ADDENDUM NO. 1

April 1, 2022

**PROJECT: Jerome Elementary School
Jerome School District
Jerome, Idaho**

M2.7
HVAC FLOOR PLAN - ADD
ALTERNATE 1 & 2

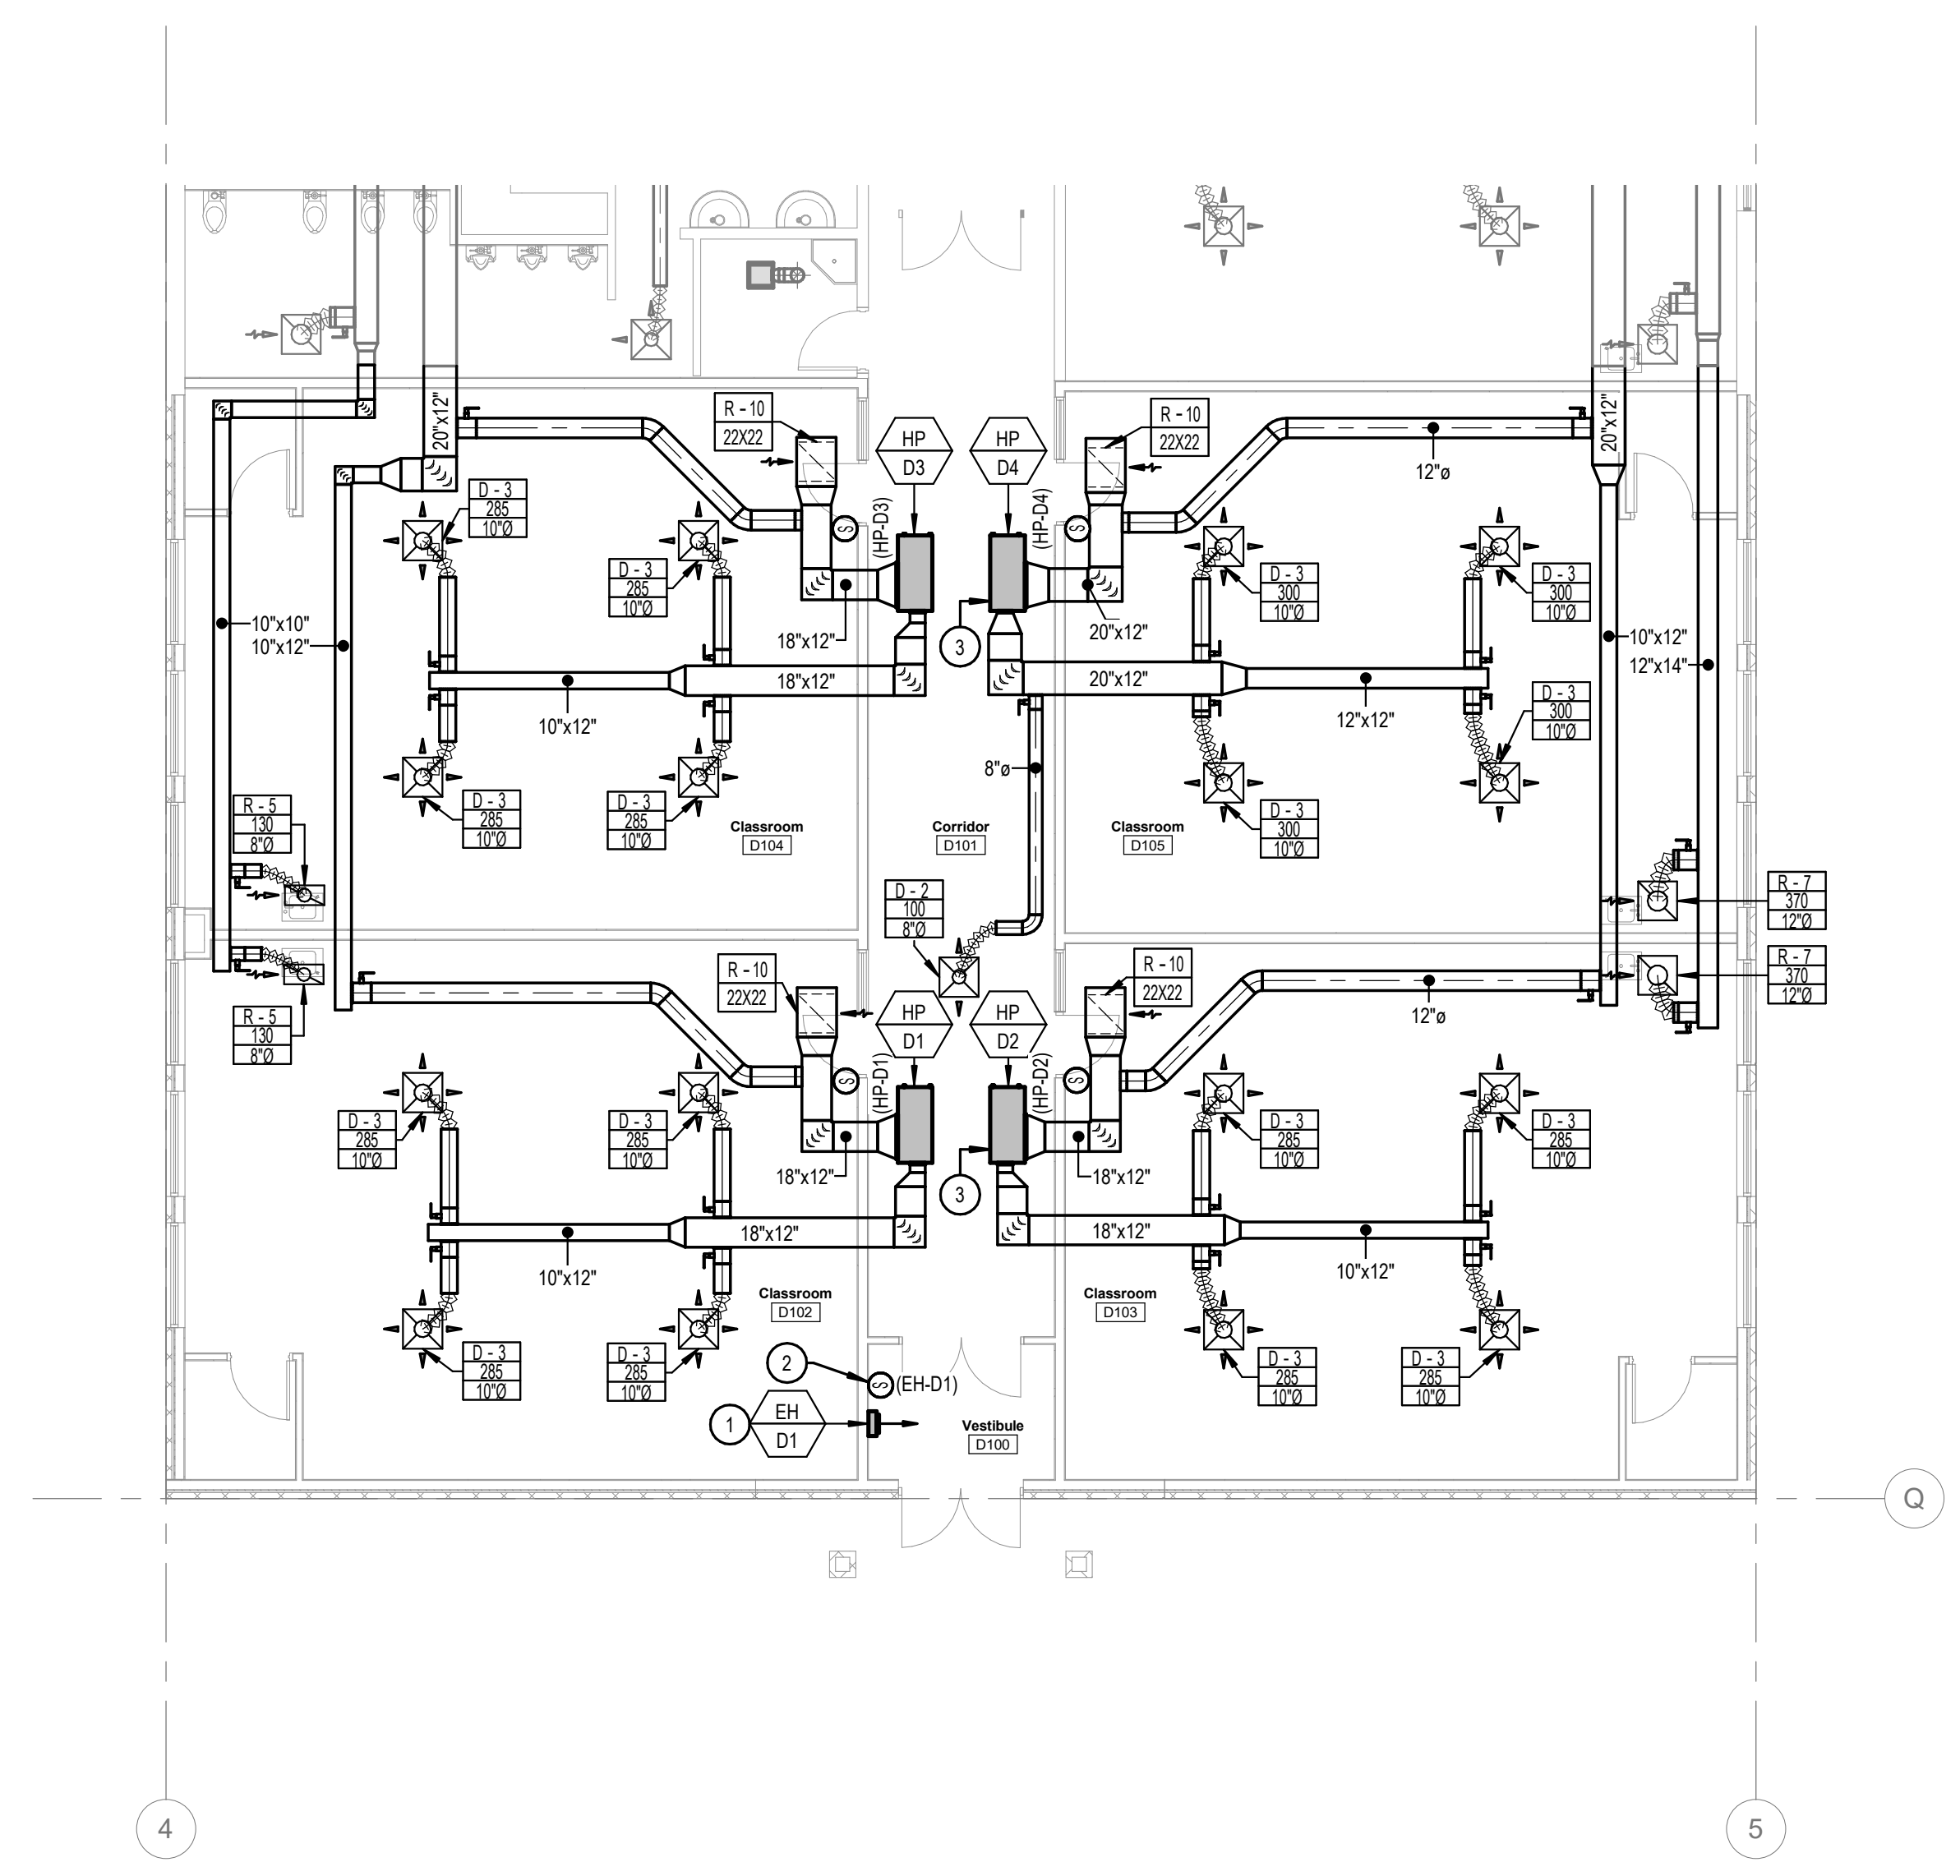
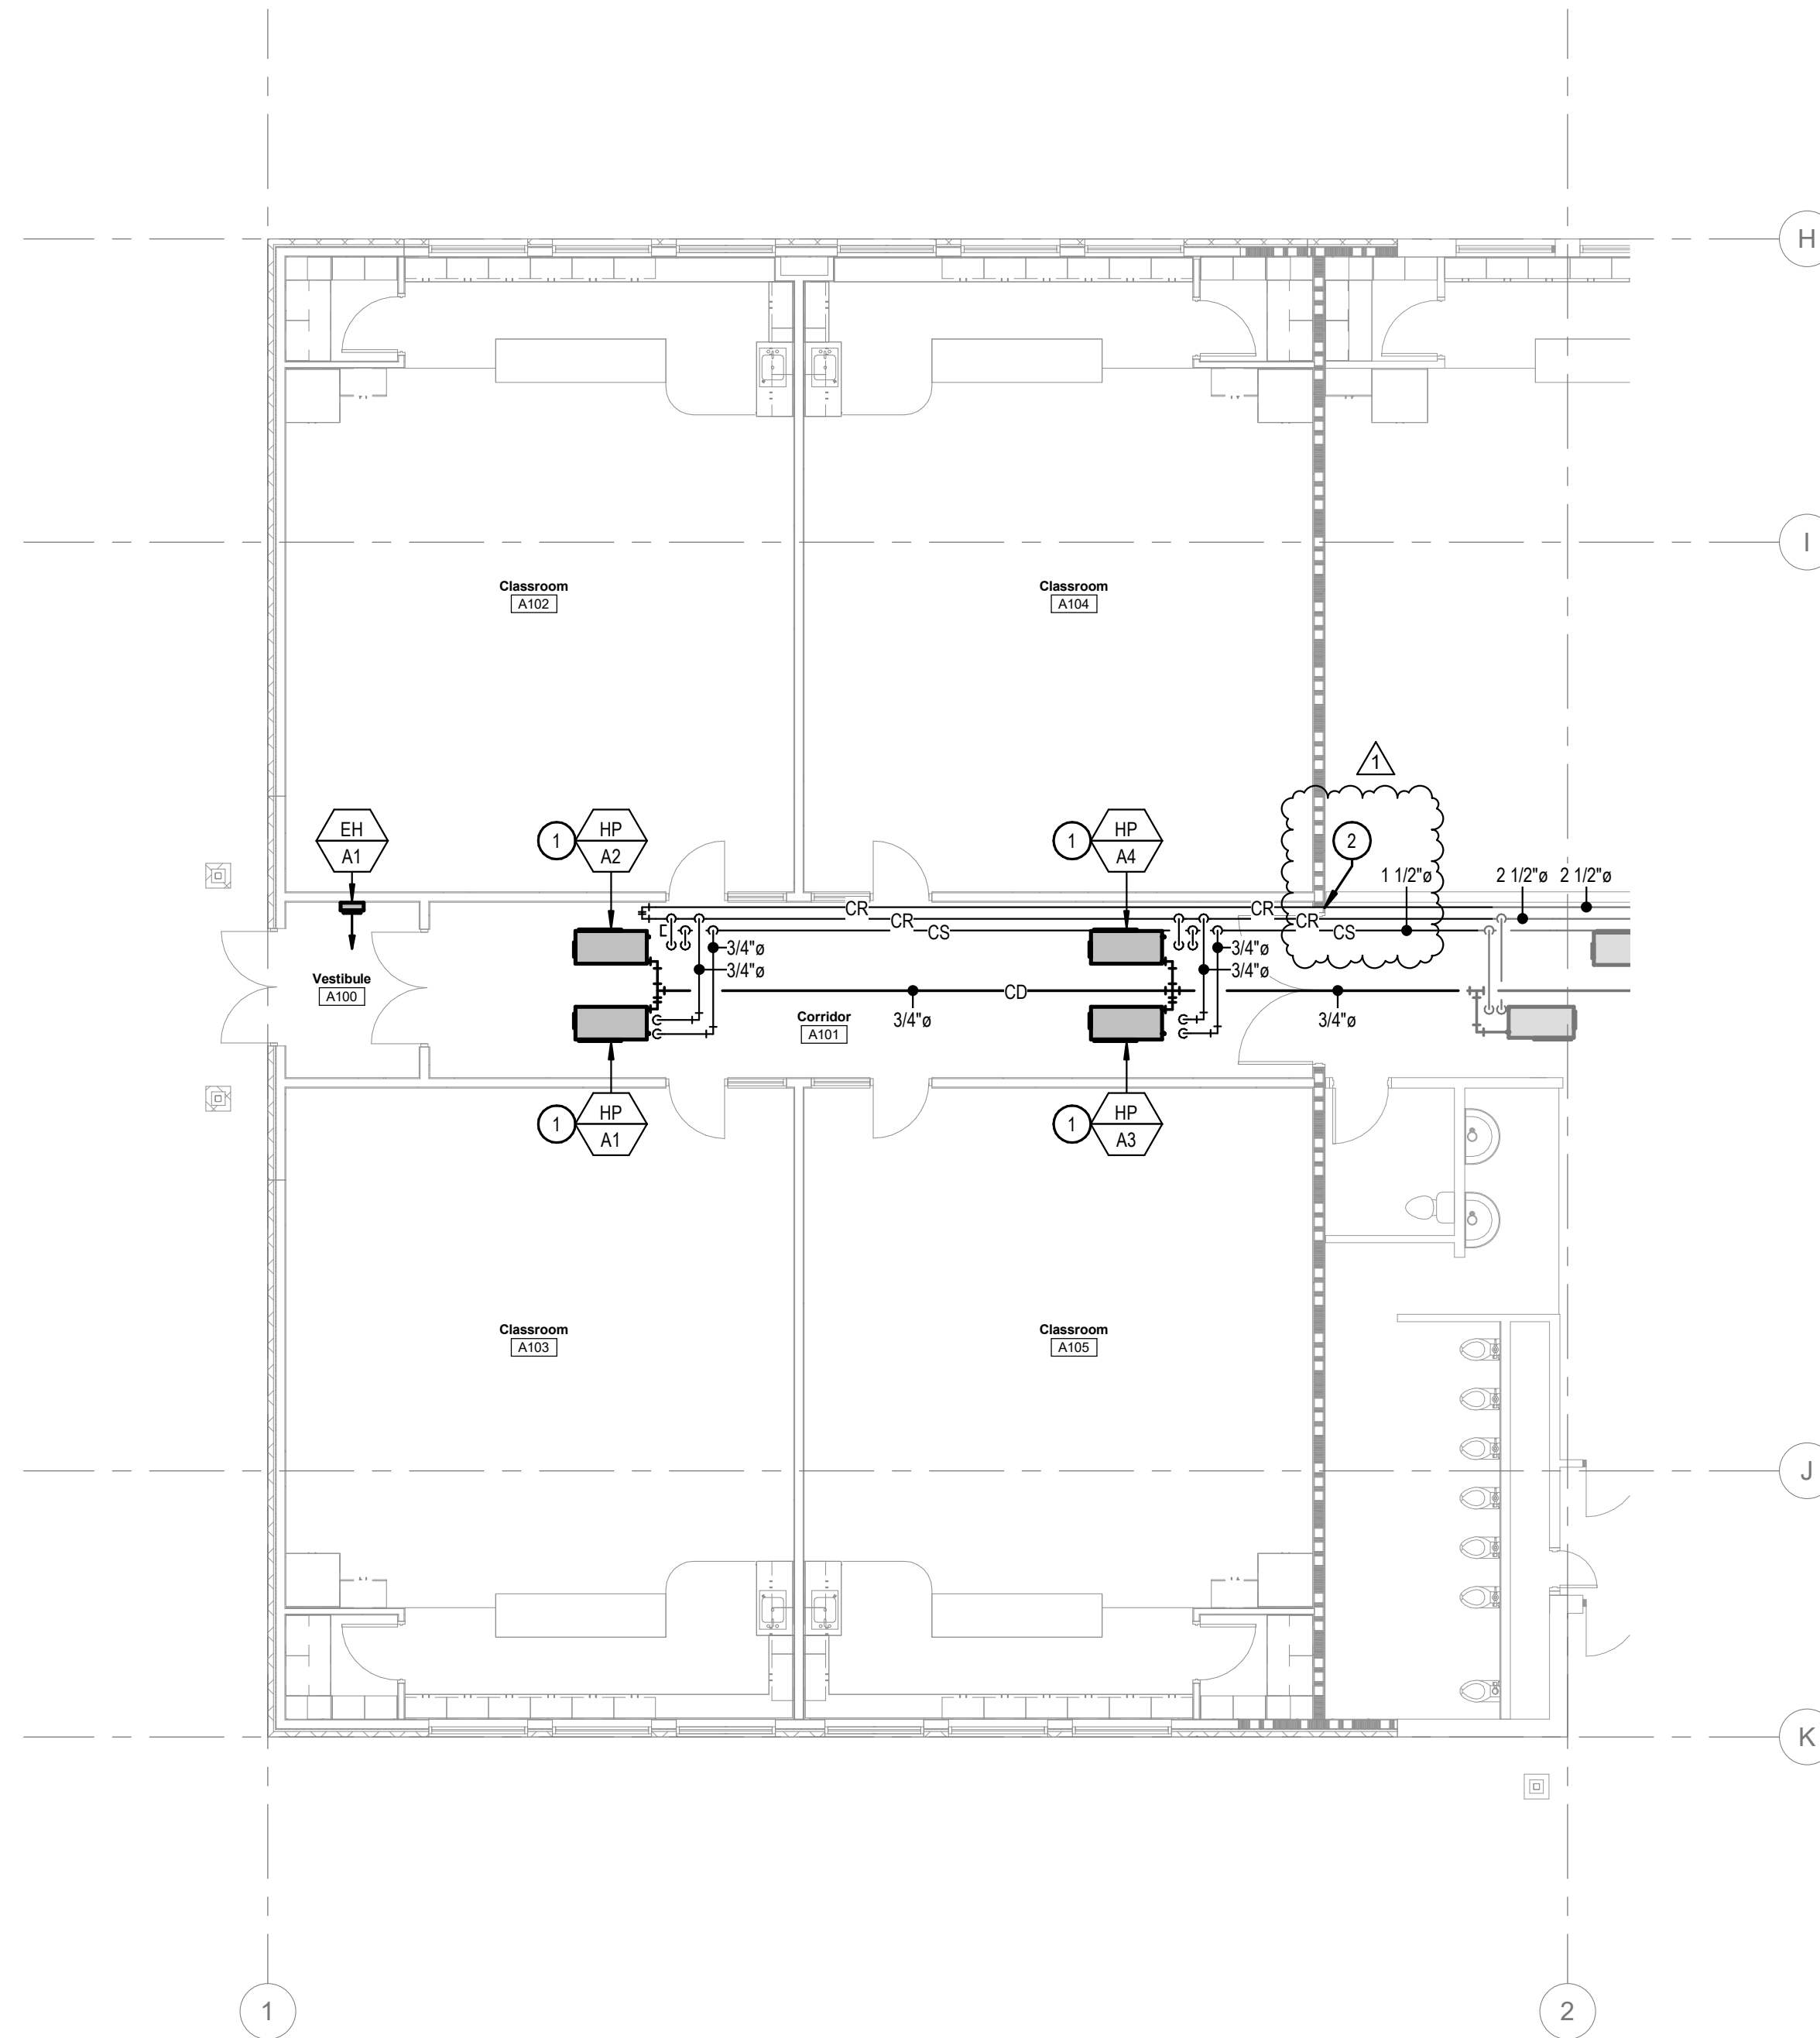
1. Sheet M2.5 – HVAC FLOOR PLAN – AREA E
 - a. Flipped spaces Toilet E108 & Janitor E109.
 - b. Updated EF-E1 location in Janitor E109.
 - c. Updated R-2 return grille location in Toilet E108.
2. Sheet M2.7 – HVAC FLOOR PLAN – ADD ALTERNATE 1 & 2
 - a. Added fire dampers to rectangular fresh air and exhaust ductwork penetrating fire wall.
3. Sheet M3.7 – HYDRONIC PIPING FLOOR PLAN – ADD ALTERNATE 1 & 2
 - a. Added keyed note #2 to hydronic pipes penetrating fire wall: "FIRE CAULK AROUND HYDRONIC PIPE PENETRATIONS THROUGH FIRE WALL."
